TECHNICAL SERVICE BULLETIN

Subject: TSB for CABLE P/N 744617

Reason for Change

INCORRECT CABLE INSTALLED AT FACTORY MAY CAUSE DAMAGE TO WIRING

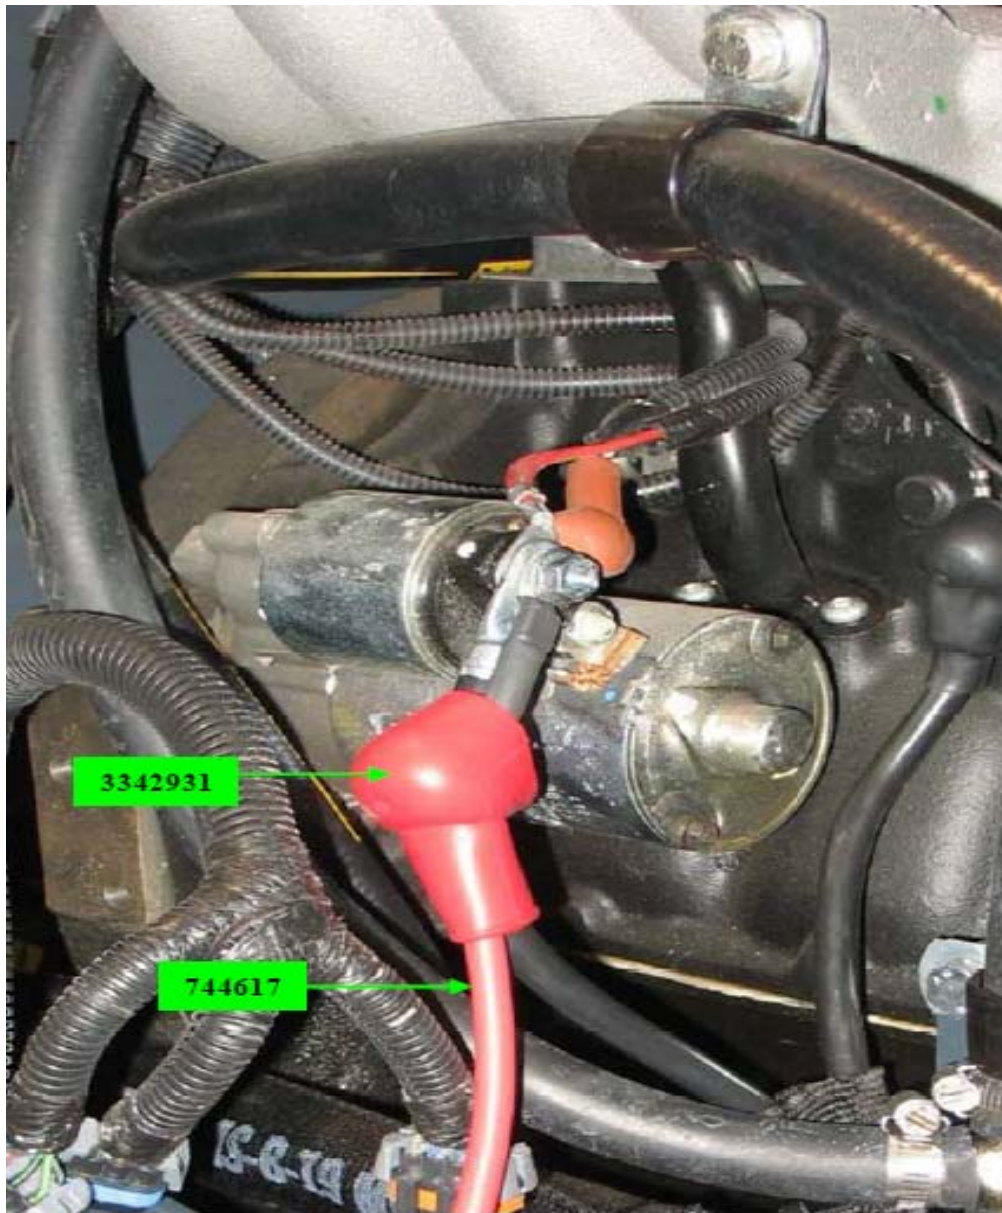
REMOVE OLD CABLE FROM STARTER AND INSERT NEW CABLE 744617 THROUGH 3342931 BOOT AND REINSTALL.

VIEW OF WIRES ROUTED THROUGH BOOT

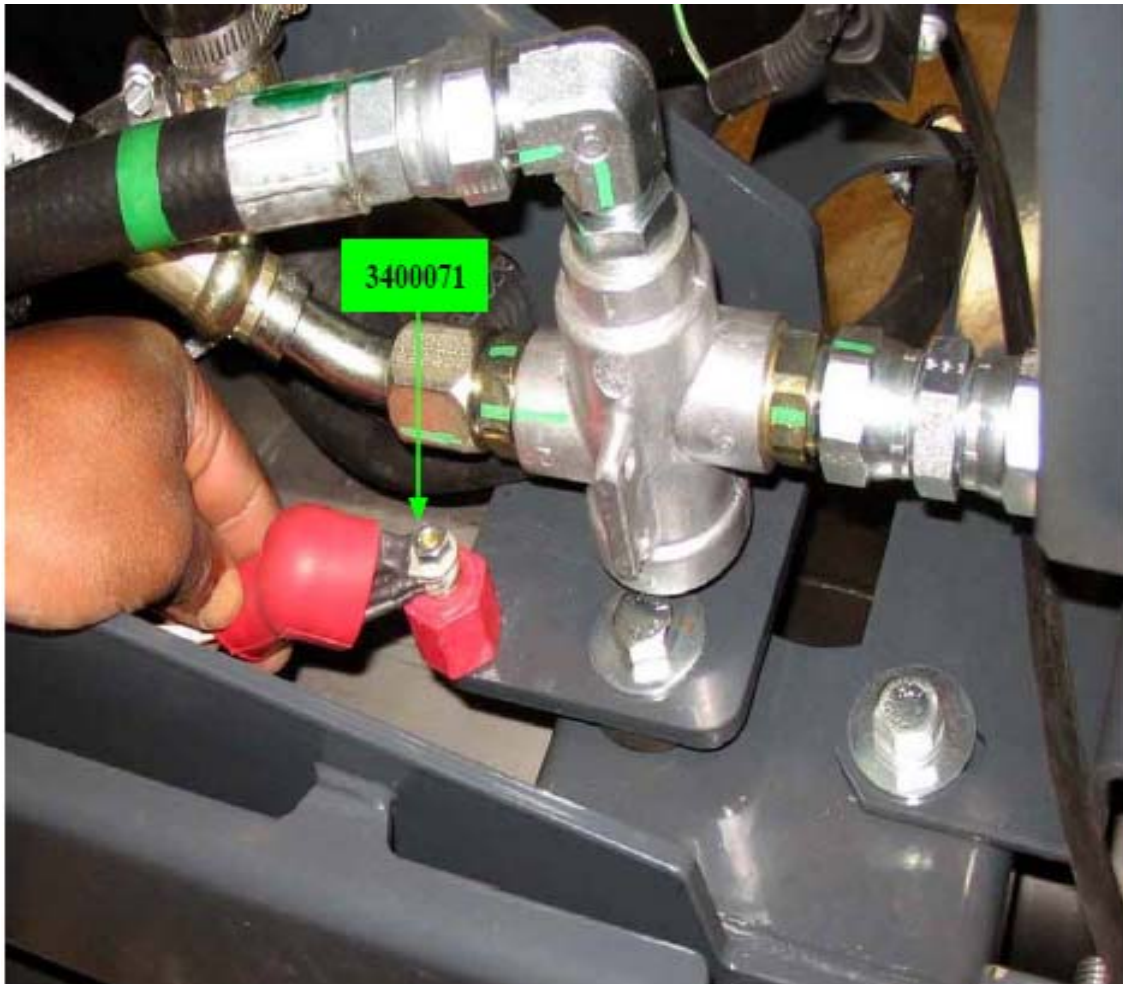
REMOVE OLD CABLE FROM ISOLATOR AND RED BOOT. REPLACE WITH NEW 744617. ROUTE CABLE THROUGH RED BOOT AND MOUNT TO INSOLATOR DISTRIBUTION POINT (3400071)
